**WHITE LAKE TOWNSHIP
INTER-OFFICE MEMORANDUM
COMMUNITY DEVELOPMENT DEPARTMENT**

**SUBJECT: Ginko Self Storage
Amended Final Site Plan**
located on the north side of White Lake Road, west of Old White Lake Road, consisting of 2.14 acres. Currently zoned Light Manufacturing (LM). Identified as vacant parcel 12-01-127-004
Applicant: Ginko Investments, LLC

RE: **Ginko Self Storage -Final Site Plan/Final Engineering Plan Review-4th Review**
~~Stormwater Maintenance Agreement Review-1st Review~~

Revised Final Site Plan Review for Special Land Use for White Lake Charter Township, Michigan

LB 15 - LB 3 PROFILE

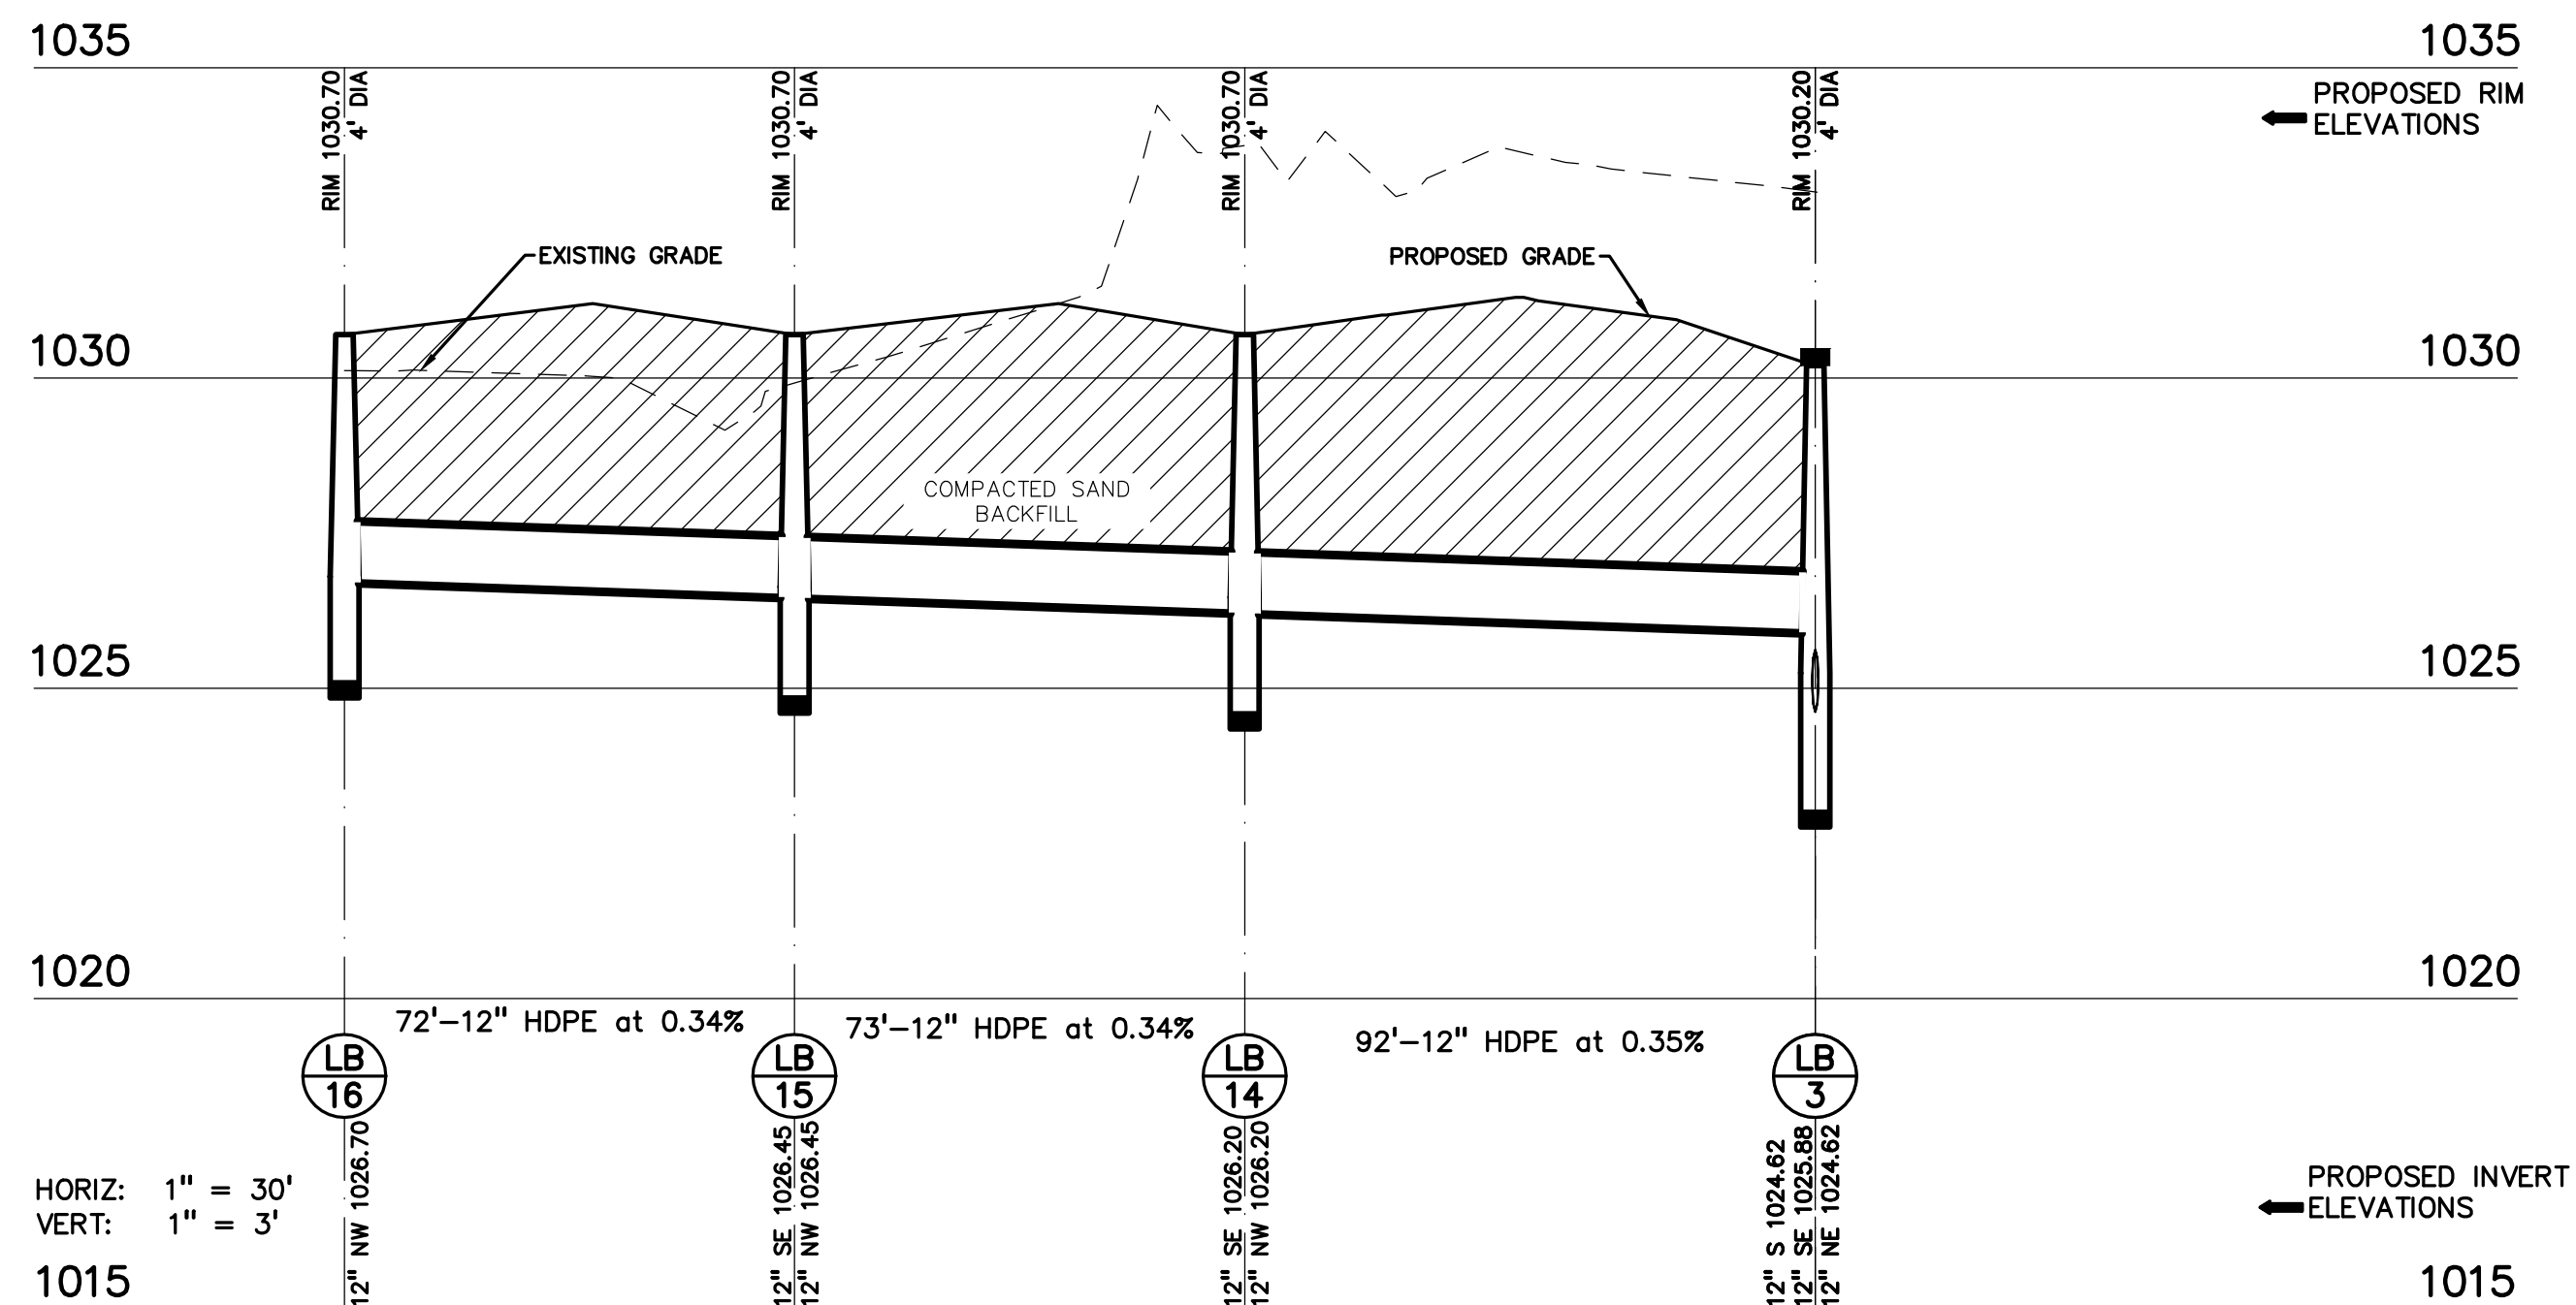
3. Sheet C-7.0- It appears that profiles were not updated based on revised storm sewer structure rim and invert elevations. We have attached a red lined copy of this sheet.
